Activbody Inc completed a minor improvement change for the device, to replace one internal plastic material:
The new frame plastic material has improved elasticity, to allow easier opening of the device upper case. This improves user experience when opening the device, and makes the plastic snaps more flexible. The change is as follows:

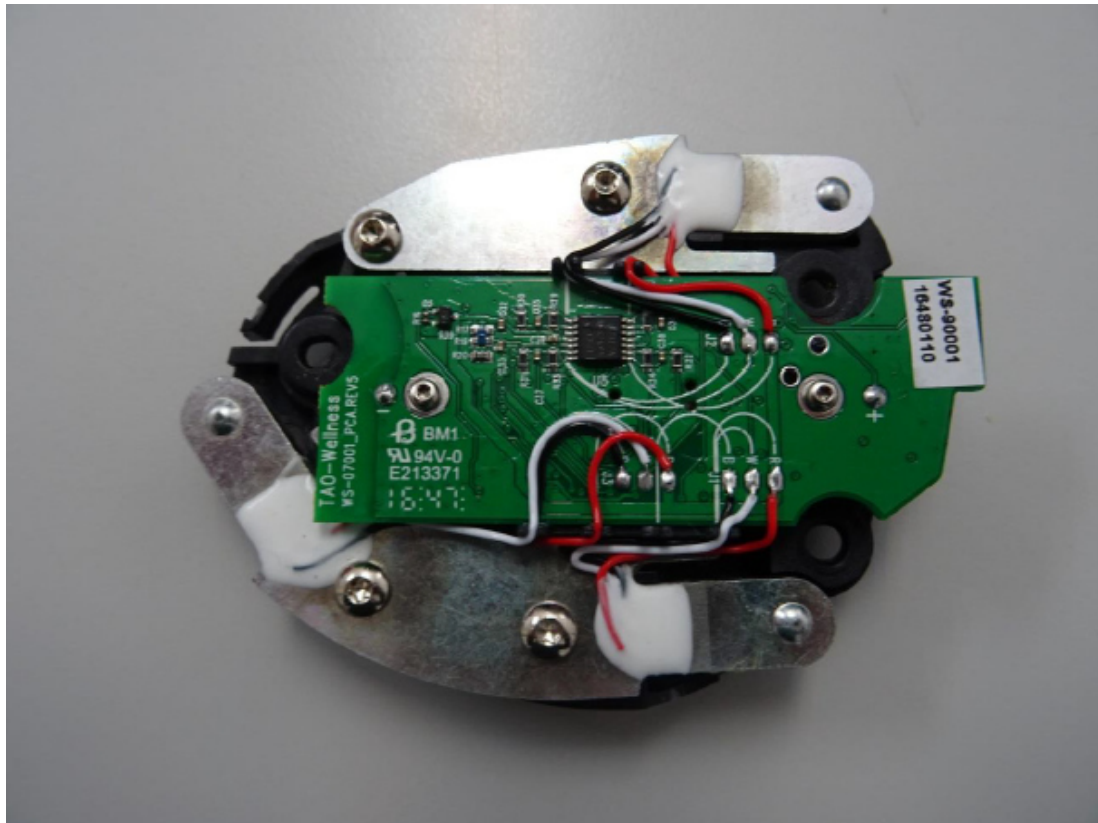
Change from: Glass Filled (GF) ABS plastic with 20% glass content,
To: Glass Filled (GF) Polycarbonate (PC) plastic with 10% glass content

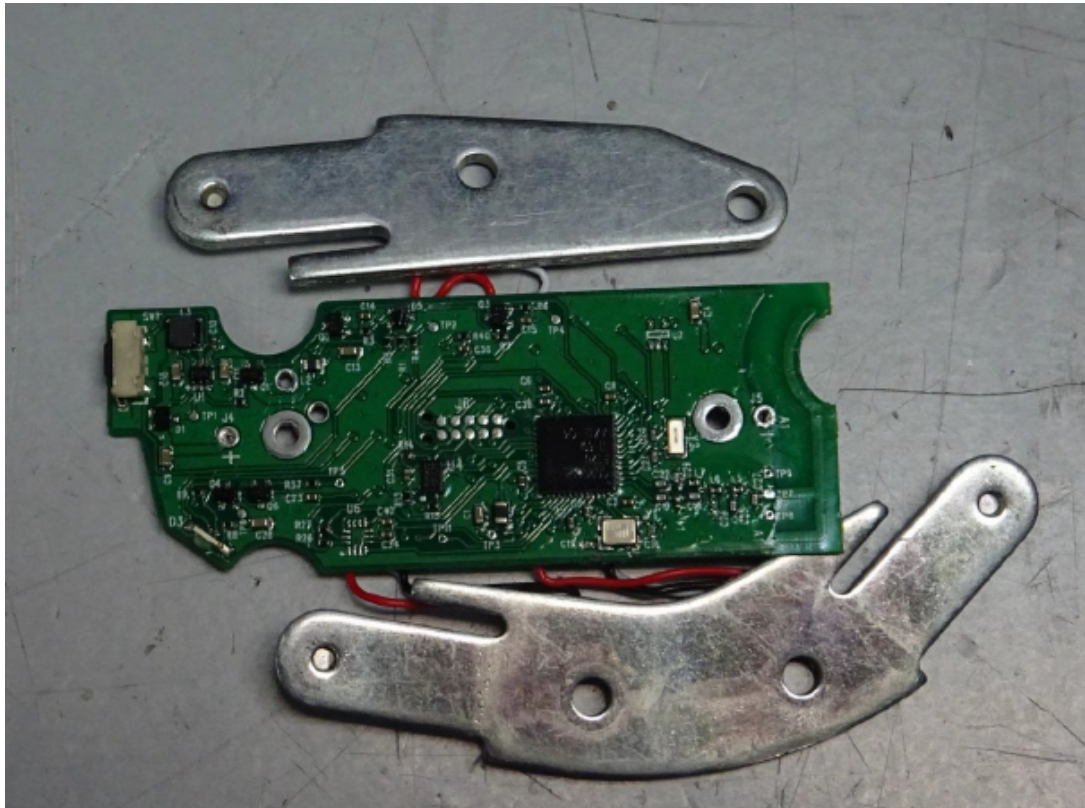
Activbody Inc completed a minor improvement change for the device, to replace one internal plastic material:
The new frame plastic material has improved elasticity, to allow easier opening of the device upper case. This improves user experience when opening the device, and makes the plastic snaps more flexible. The change is as follows:

Change from: Glass Filled (GF) ABS plastic with 20% glass content,
To: Glass Filled (GF) Polycarbonate (PC) plastic with 10% glass content
